# **Responses to DNR comments on mining permit application. November 11, 1983**

November 11, 1983

## Responses to DNR Comments on the Mining Permit Application

(FIGURE 1 FOR RESPONSE TO COMMENT NO. 7.

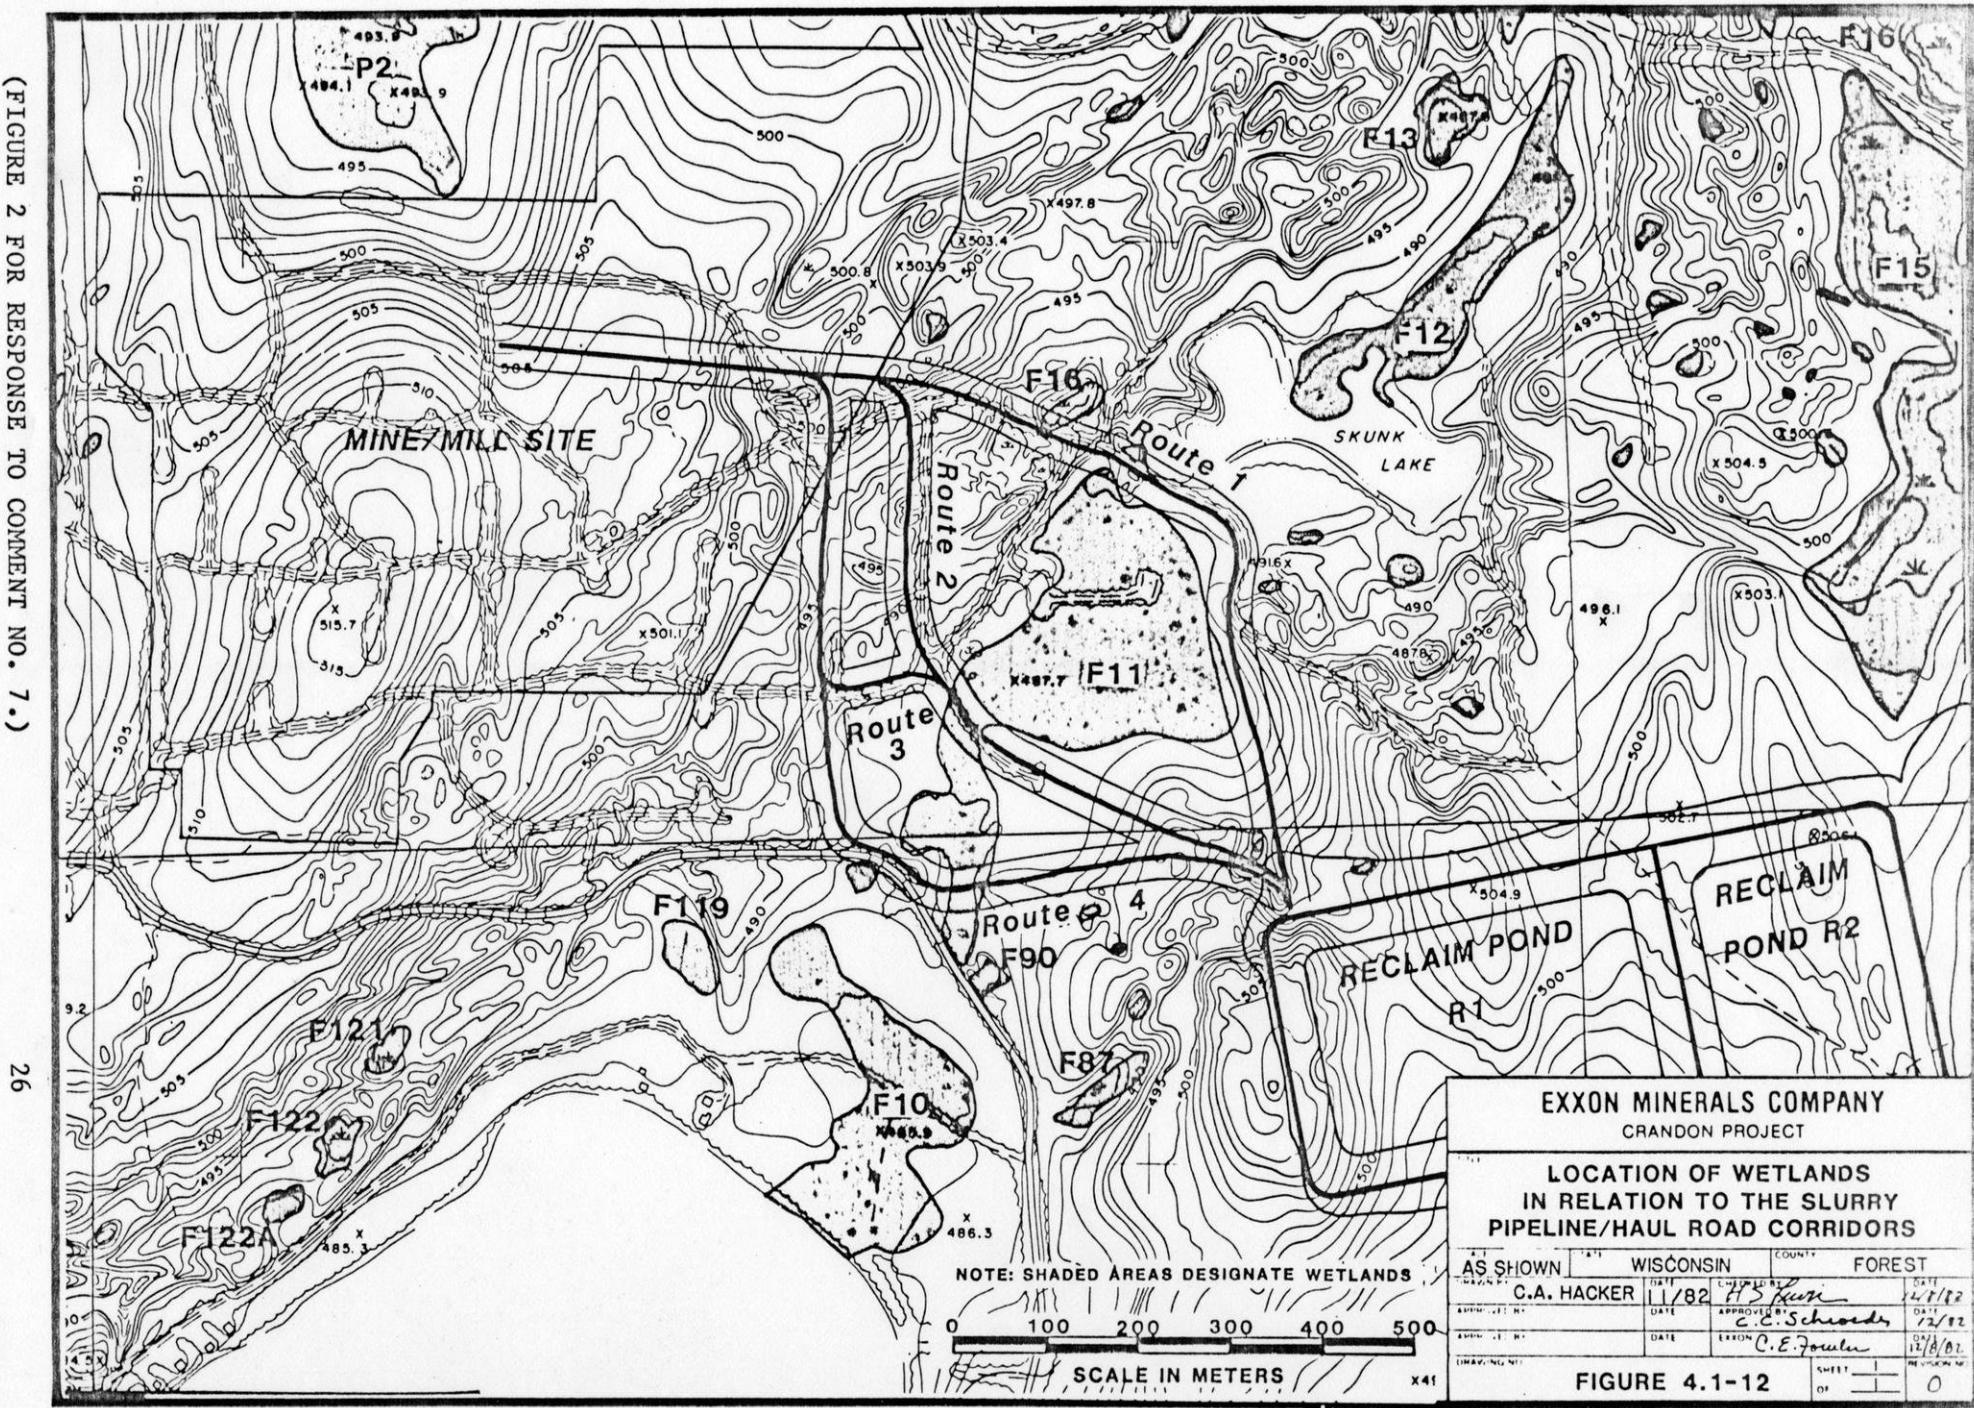
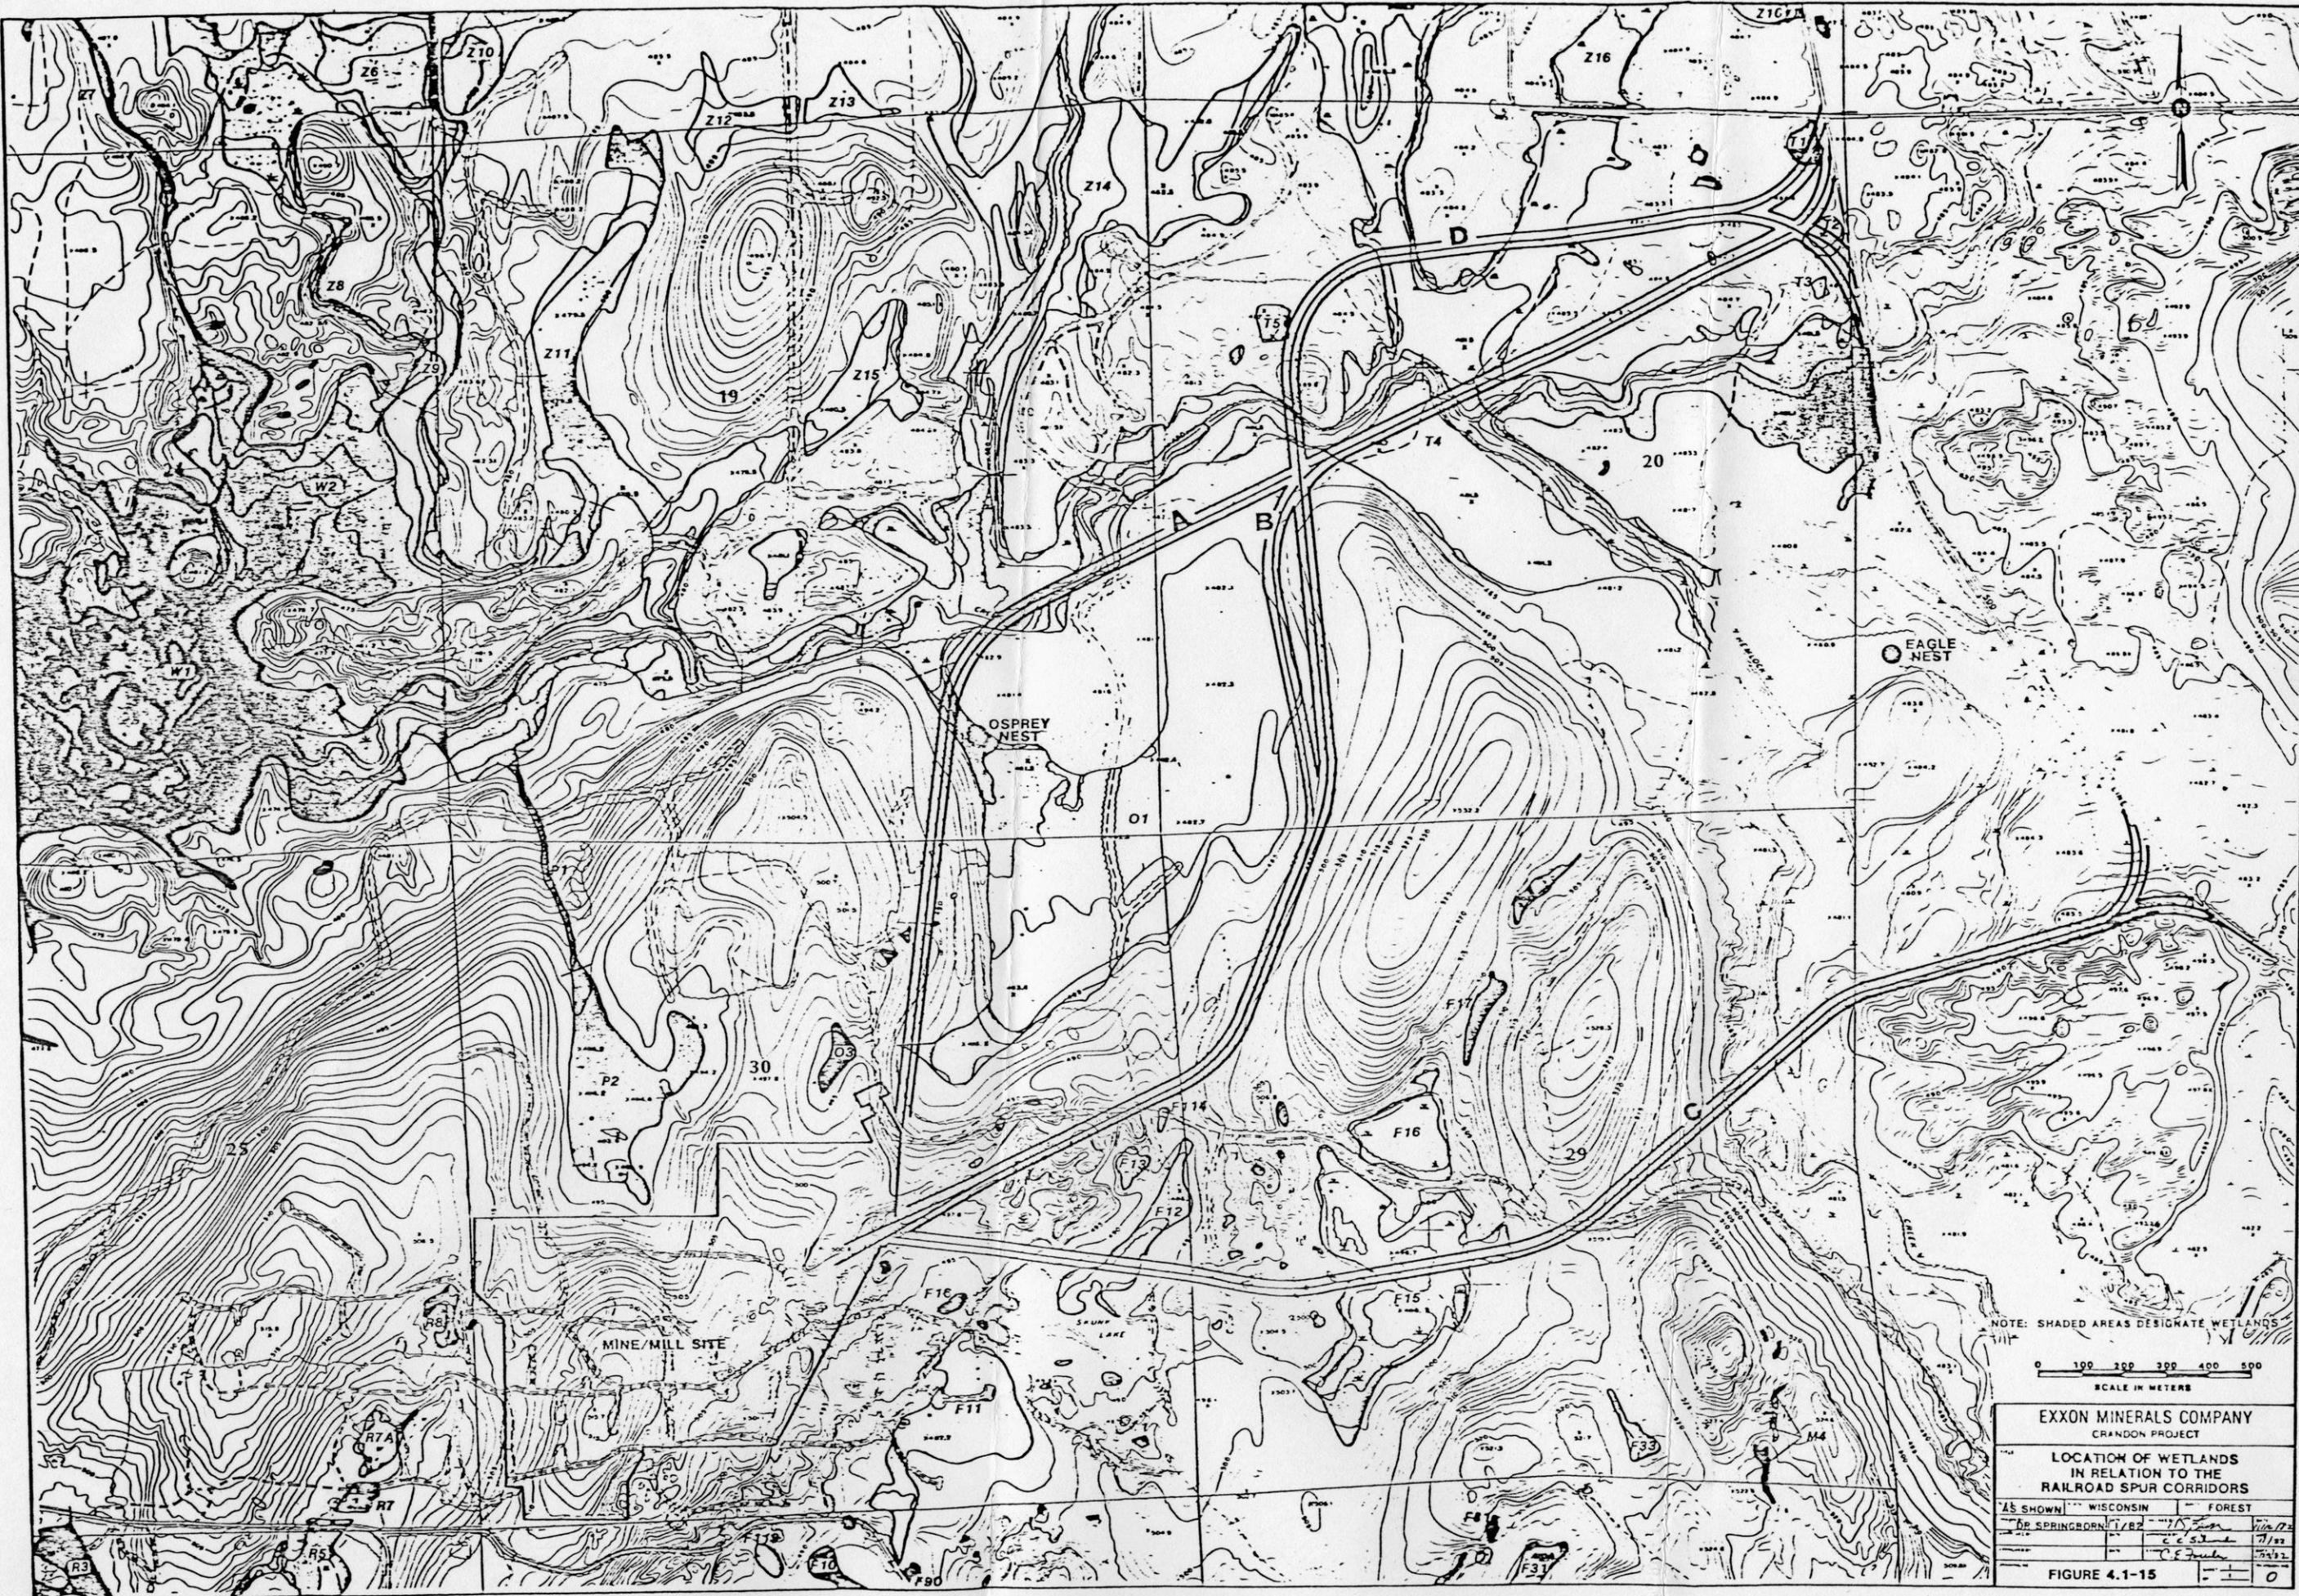
Section A, Item 14 - Are the Wetlands Assessment Report and Inventory considered part of this permit application? If not, maps should be provided to show the proposed site and the potentially affected wetlands. If the reports are part of the application, they should be attached.

The Wetland Assessment Reports dated August 1982 and August 1983 are not considered part of the Mining Permit Application. Figures 1 through 8 (attached) will be included in the revised Section A, Item 14 of the Mining Permit Application to show wetlands that could potentially be affected by proposed or alternative Project facilities.

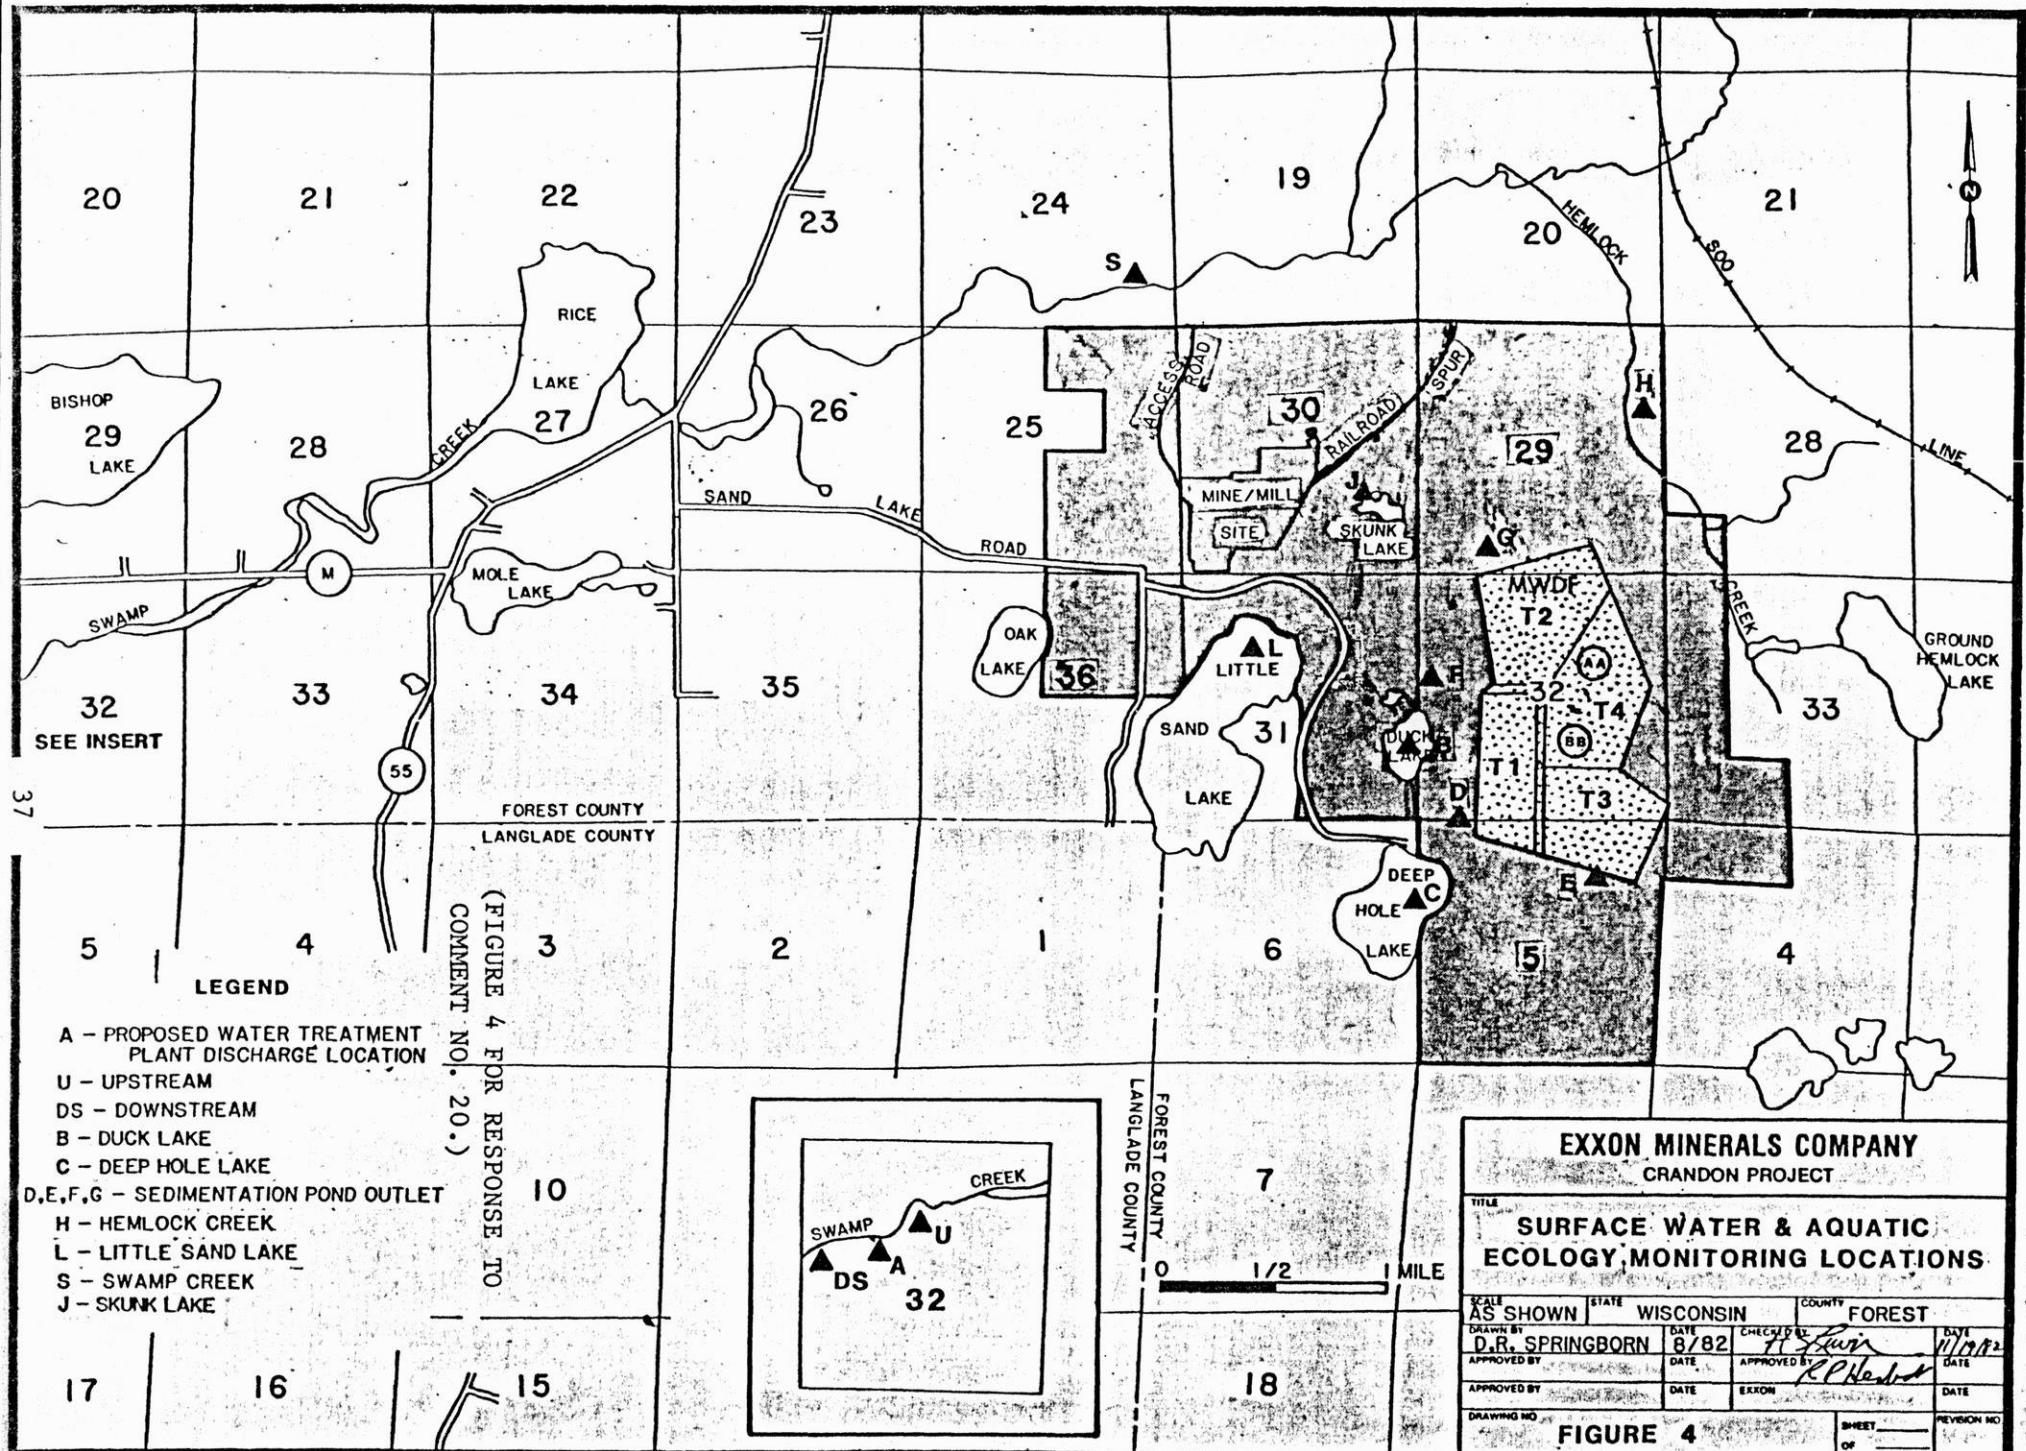
Table 3 lists Skunk Lake as a sampling location. However, the site for Skunk Lake is not included in Figure 4. Please clarify.

Hoffman Springs should be included in the surface water monitoring program.

Figure 4 (attached) has been revised to include the location where monitoring will occur in Skunk Lake.

Section 3.0, including Figure 4 and Table 3, in the Monitoring and Quality Assurance Plan will be revised to include Hoffman Springs in the surface water monitoring program. Hoffman Springs is located on the perimeter of the 1 m (3.3 feet) drawdown area; however, because it supports a brook trout population downstream in Hoffman Creek, it is considered a more sensitive water body than others in the immediate area. Also, the main source of water for the springs and Hoffman Creek is ground water.
